Your Ref
APP/15/01421

Our Ref
PLAN-012947

Proposal: First floor rear extension to form level access shower room.

Site: 10 Sea Front, Hayling Island, PO11 9HL.

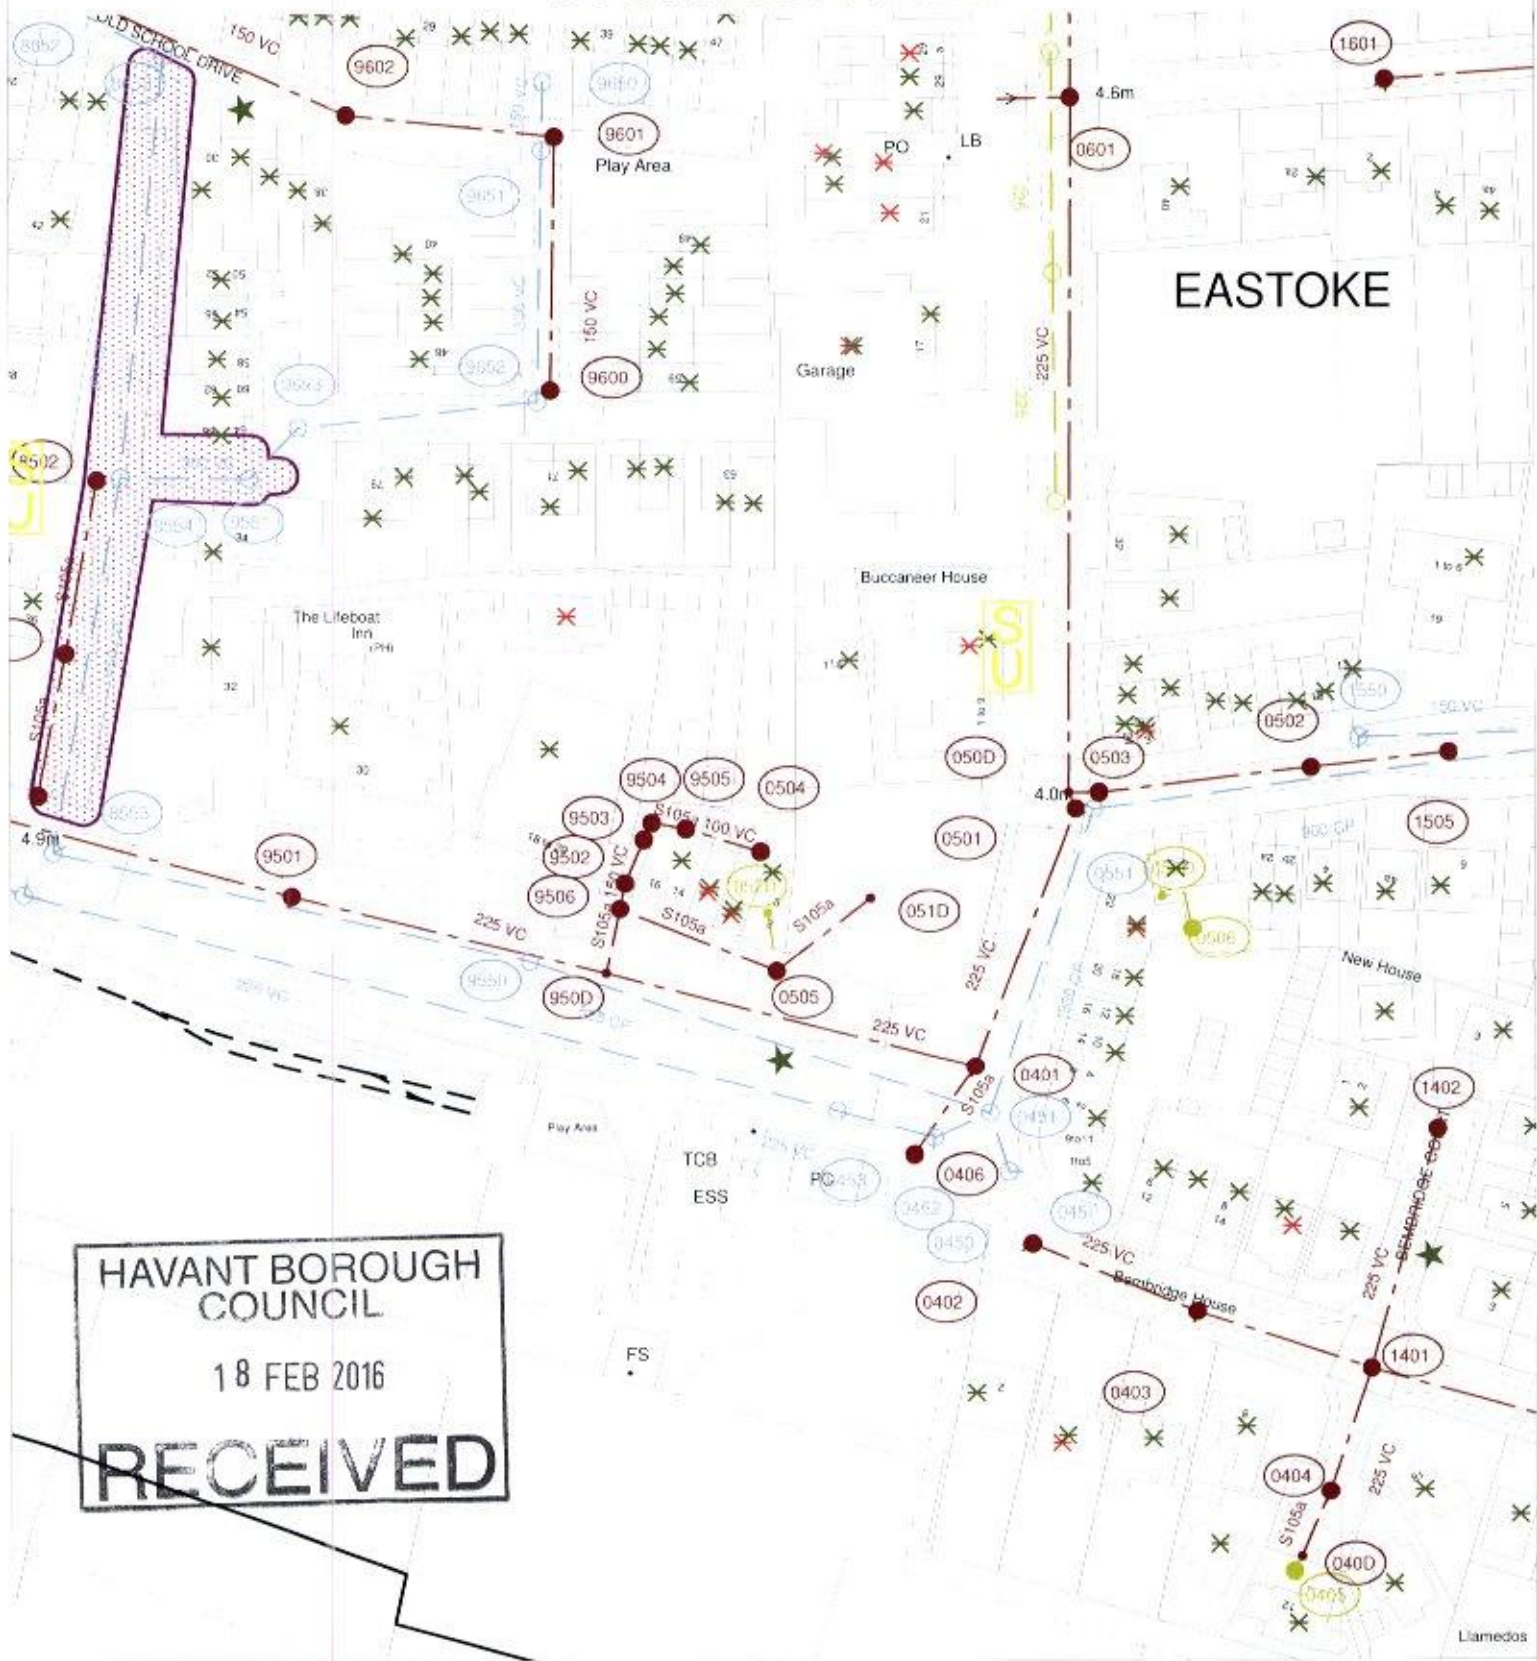
Please find attached a plan of the sewer records showing the approximate position of a public sewer within the site. The exact position of the public sewers must be determined on site by the applicant before the layout of the proposed development is finalised.

Any changes to the building foundations will require Southern Water approval. The design for additional loads should take into account of that construction that will be affecting the public apparatus. In order to protect public apparatus foundations should be taken down 150mm below the invert level of the sewer.
